1 **Comment (Comments: #74, #37, #108, #83)**

9 **33.3.3 PD state diagram**

33 **33.3.3.11 Type 3 and Type 4 dual-signature constants**

Figure 33-33—Type 3 and Type 4 dual-signature PD state diagram (continued)

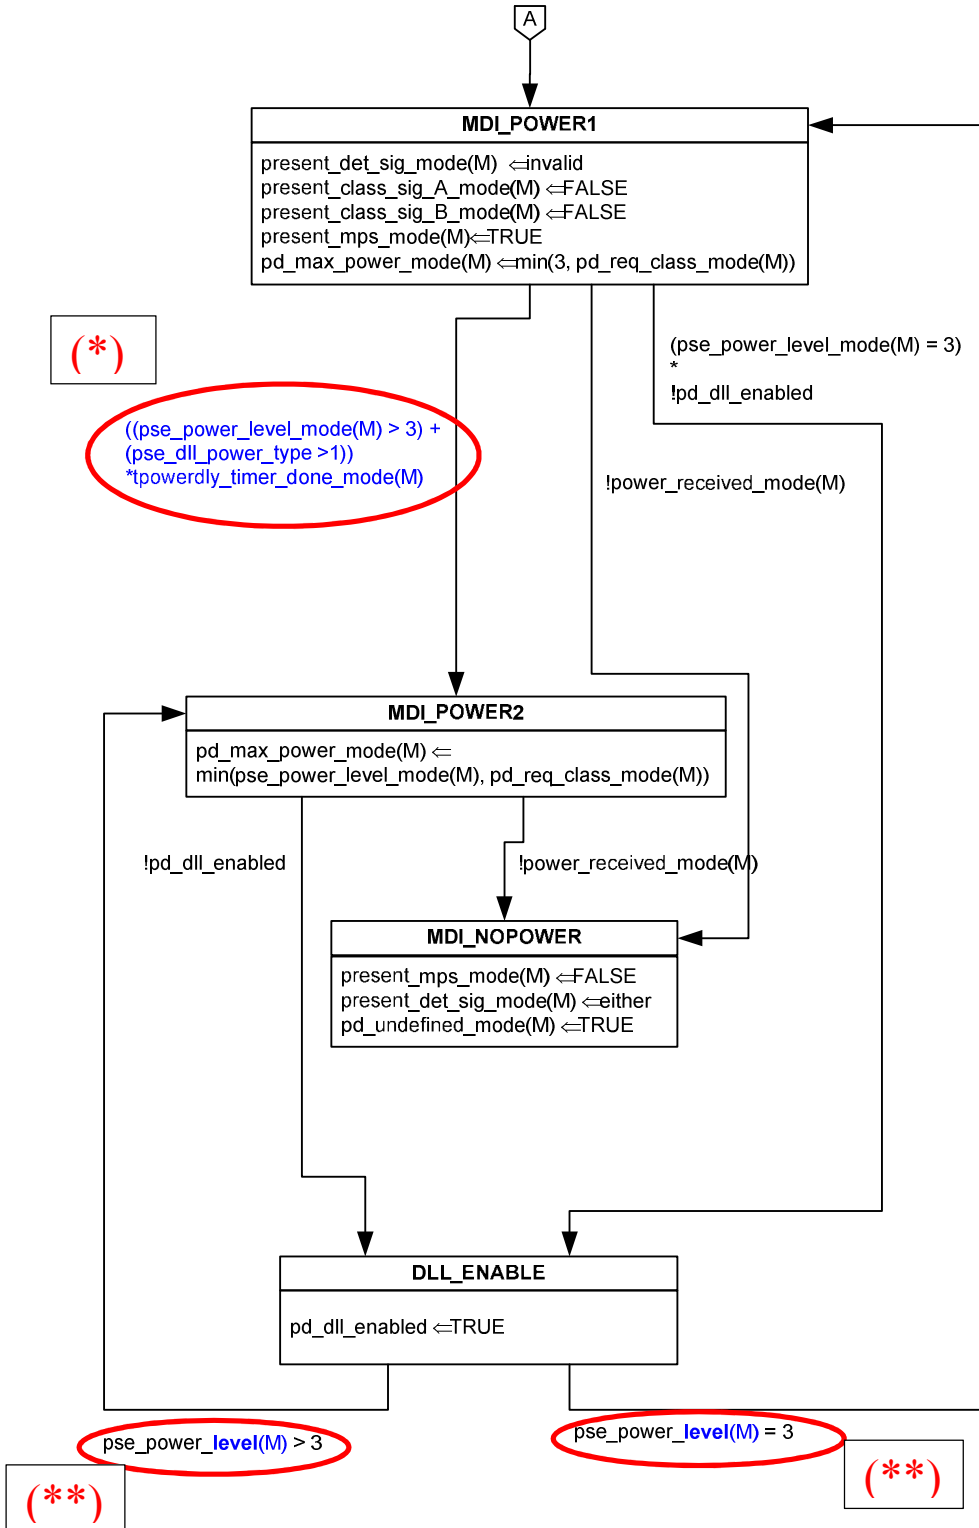
20 Page 145 Figure 33-33: Replace “Vpd(M)” with “Vpd_mode(M)”

21 Page 146 Figure 33-33: Update the stste machine as follows:

(*) Same improvement was used in single-signature state diagram and may be implemented here as well.

(**) It is pse_power_level and not pse_power_type as in the approved baseline from September 2016 and was not implemented. See ref 1.

1 Make the following changes in Figure 33-33 on page 136 (marked in [Blue](#)):
